## ADDENDUM NO.2

**PROJECT:** Cumru Fire Department  
**ADDRESS:** 1775 Welsh Road  
Mohnton, PA 19540

**MWS PROJECT NO:** 18-036  
**DATE:** 1/5/2024

PROJECT  
18-036  
PROJECT  
BID SET  
DATE  
11/30/2023  
DRAWING  
PART FLOOR PLANS -  
ELECTRICAL  
SHEET  
**E301**

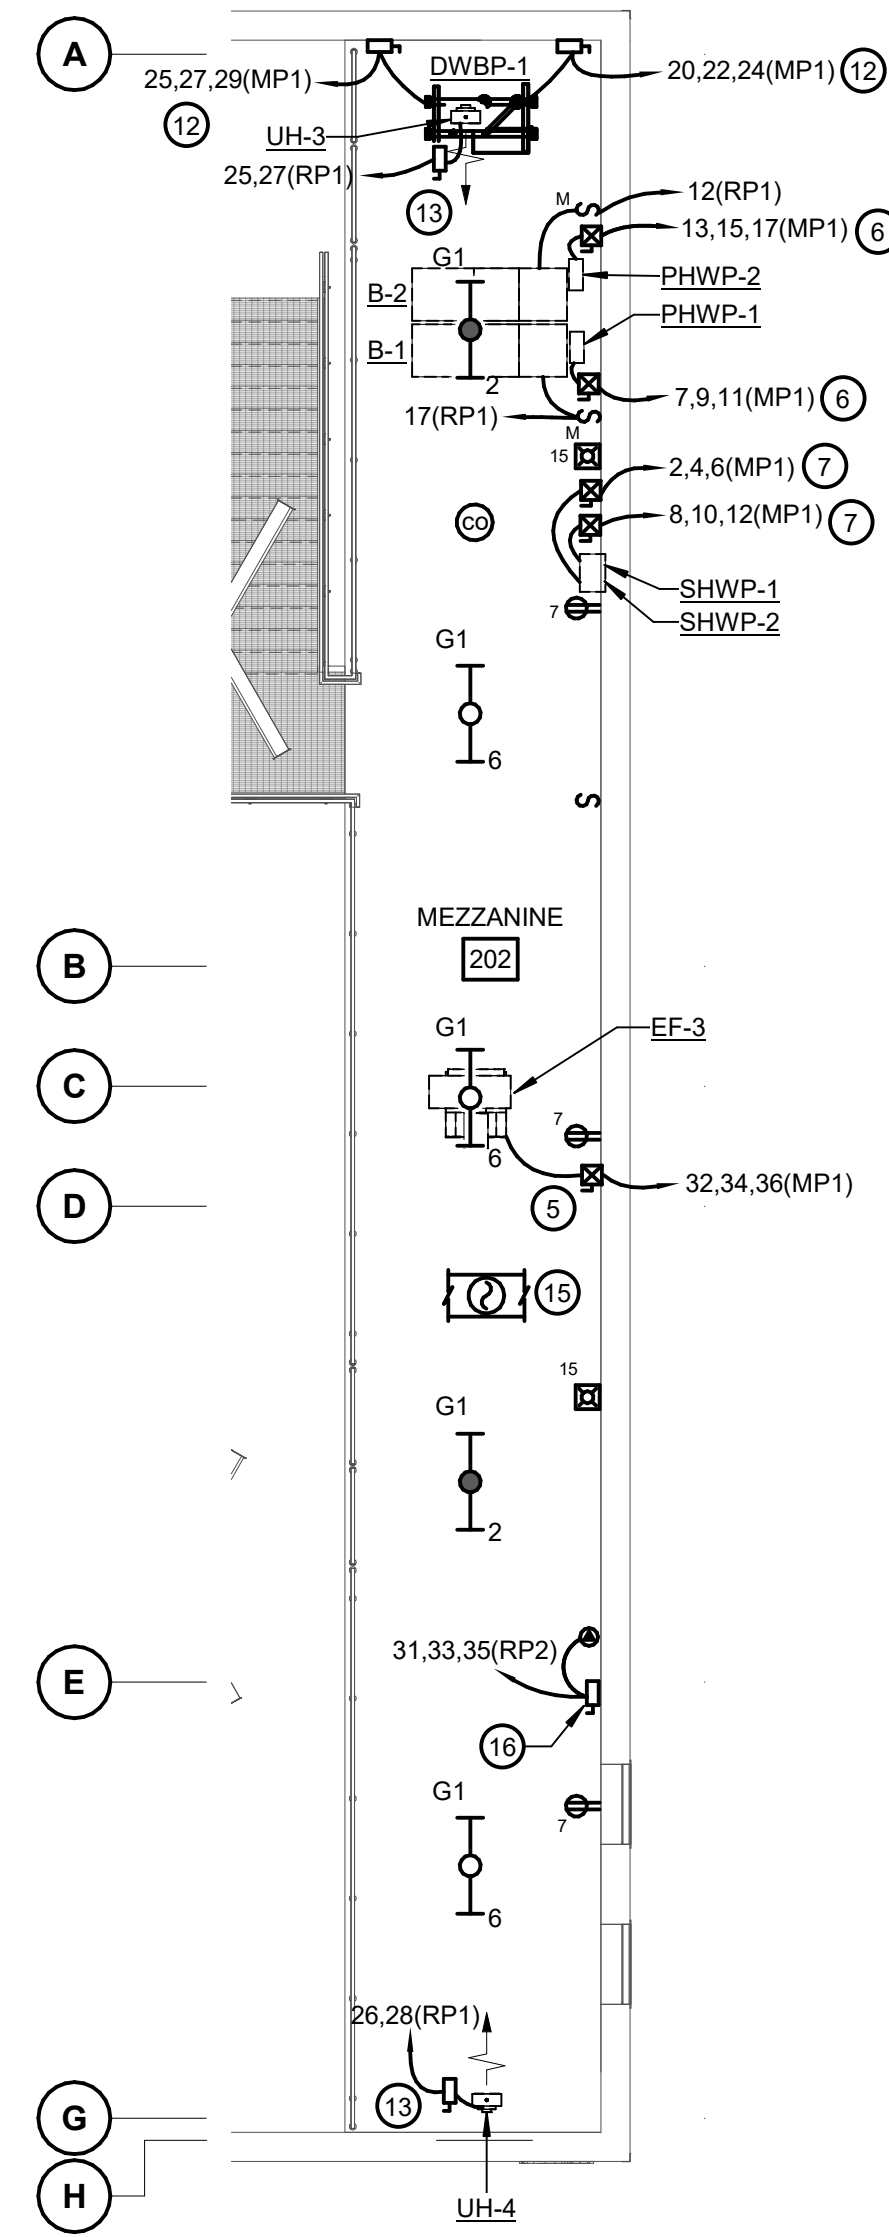
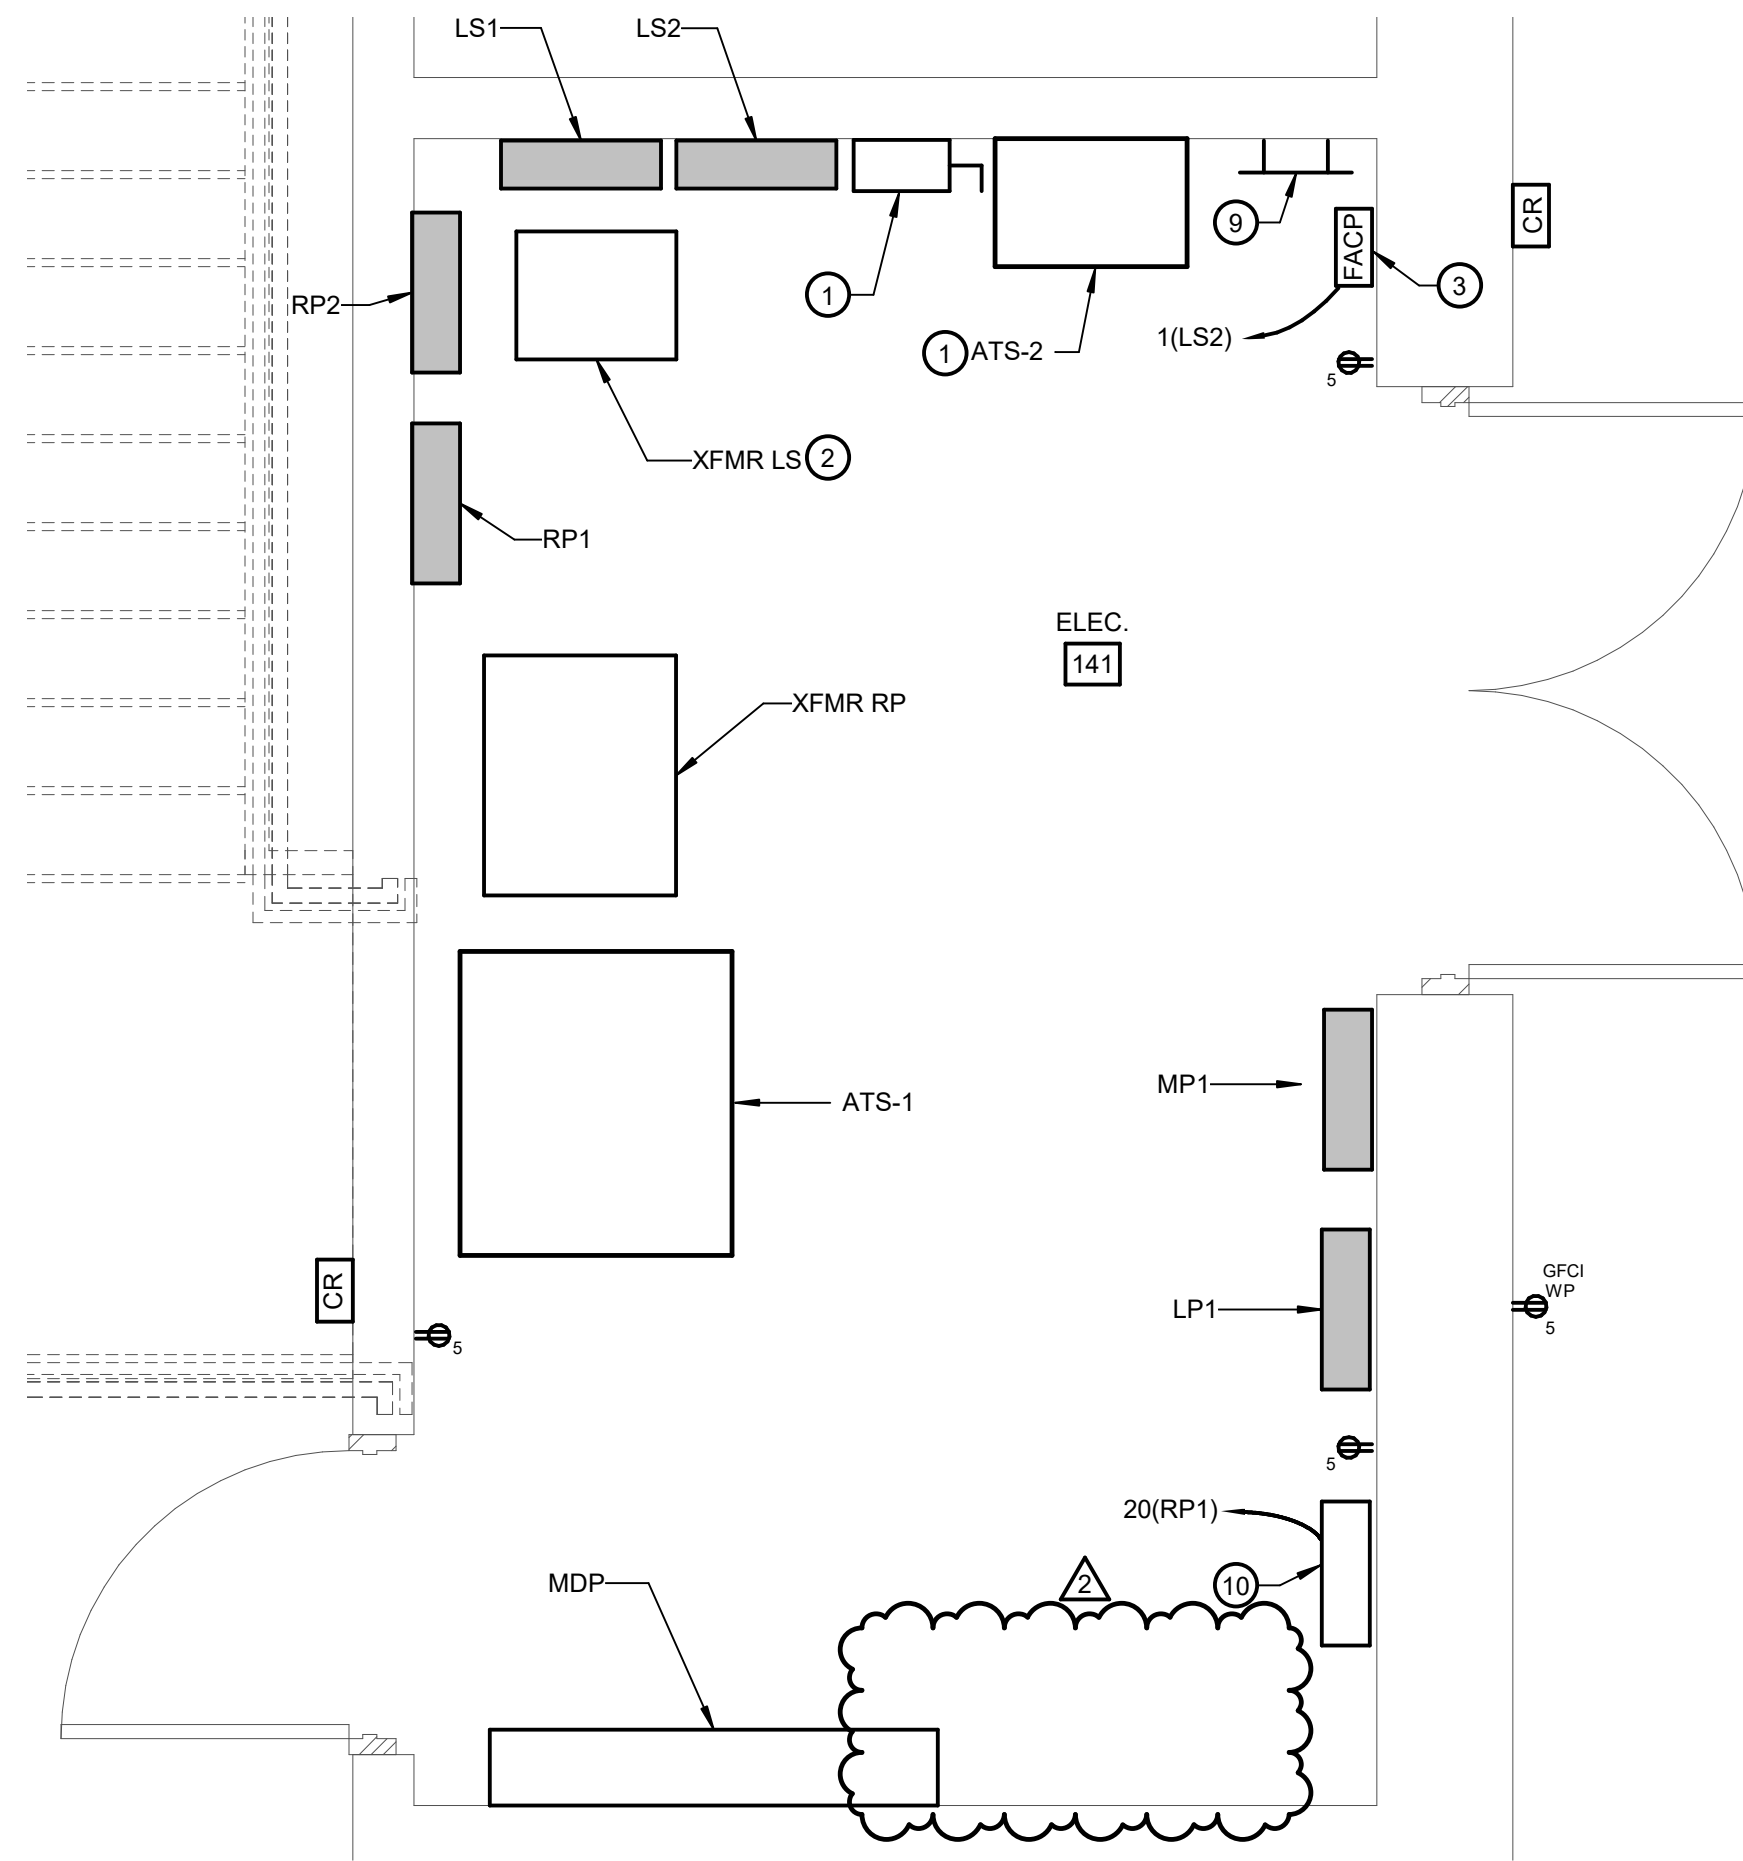
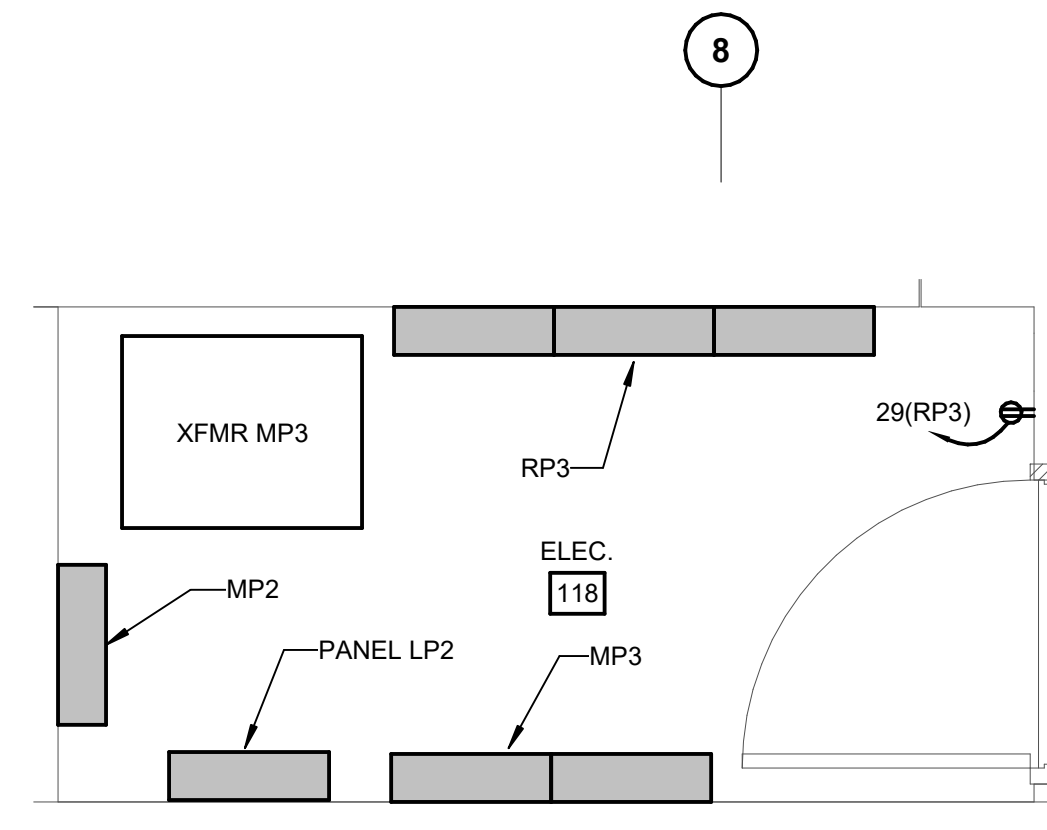
- 24.) **QUESTION:** There is not a light switch shown in room 129.  
**RESPONSE:** Light switch to be provided as shown on Addendum 2.
- 25.) **QUESTION:** There is an 800 amp fused safety switch shown on the exterior wall on drawing E002 that shows a note 5 next to it. There is also an 800 amp fused safety switch shown on drawing E301 that shows a note 11 next to it in the electrical room. Is this a duplicate?

**RESPONSE:** Yes, duplicate safety switch shown on drawing E301 to be removed.
- 26.) **QUESTION:** There doesn't appear to be any power on the electrical drawings for the garage doors.

NO.	DESCRIPTION	DATE
2	ADDENDUM 2	1/5/2024
PROJECT NUMBER: 18-036		
PROJECT SET: BID SET		
DATE ISSUED: 11/30/2023		
DRAWING TITLE: ELECTRICAL ONE-LINE DIAGRAM		
SHEET NUMBER: <b>E501</b>

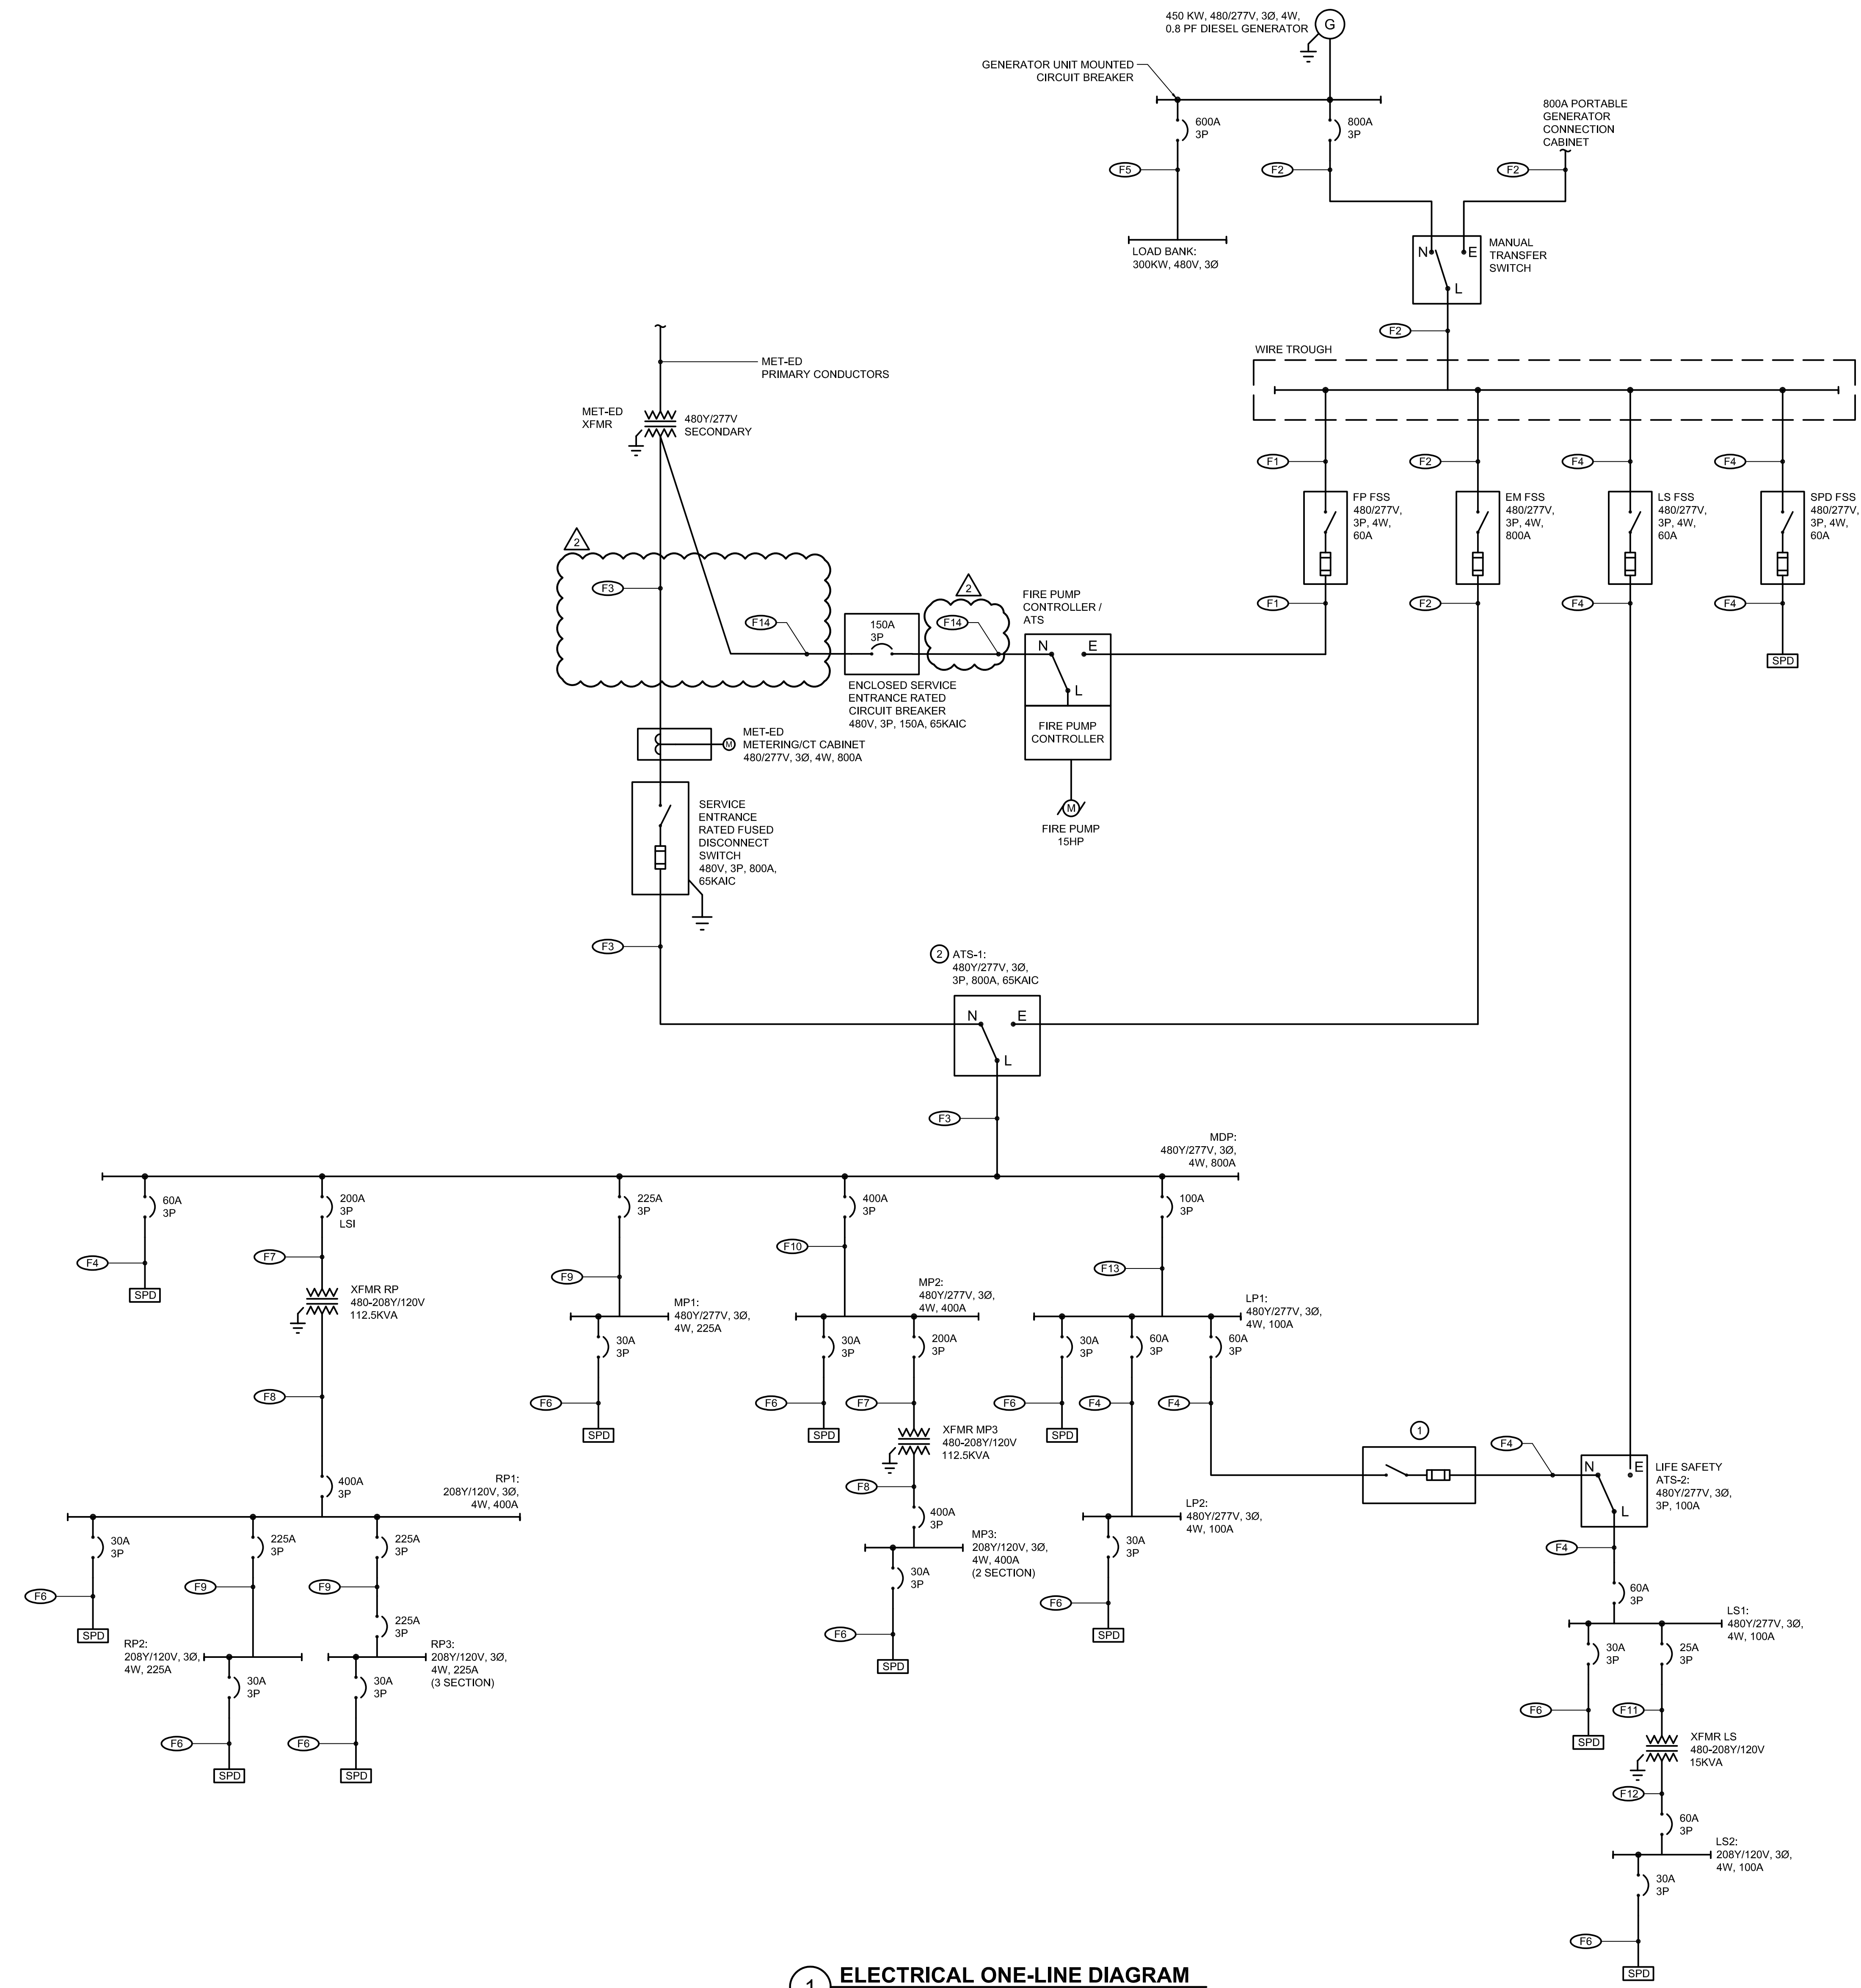
**RESPONSE:** Power for garage doors shall be provided as shown in Addendum 2.
- 27.) **QUESTION:** Drawing E501 shows the utility transformer secondary conductors by Met-Ed. This is not typical with Met-Ed. Please advise if this is correct.

**46.) QUESTION:** Drawing E501 shows that the conductors from the transformer to the CT cabinet are by Met ED. I believe that Met-Ed will require that we provide the secondary conductors. Can you

confirm that these conductors are by Met-ED, and if not Can you provide conductor sizes for the secondary service?

**47.) QUESTION:** Drawing E501 shows that the conductors from the transformer to the Fire pump breaker to be #8 wire connected to a 150-amp breaker. The NEC will not permit #8 wire to be fused at 150 amp. Should the 150 amp disconnect be smaller, should the wire be rated for 150 amp?

**RESPONSE:** Secondary conductors shall be by 16A Electrical Prime Contractor. Refer to revised drawing E501 in Addendum 2
- 28.) **QUESTION:** There are spec sections for unit prices and alternates, but they are not shown on any bid forms. Do these only apply to contract 1A?

**RESPONSE: Provide (2) sets of 4#600kCMIL and 1#3/0 ground.**

**RESPONSE: Provide #1/0 wiring per Addendum 2.**
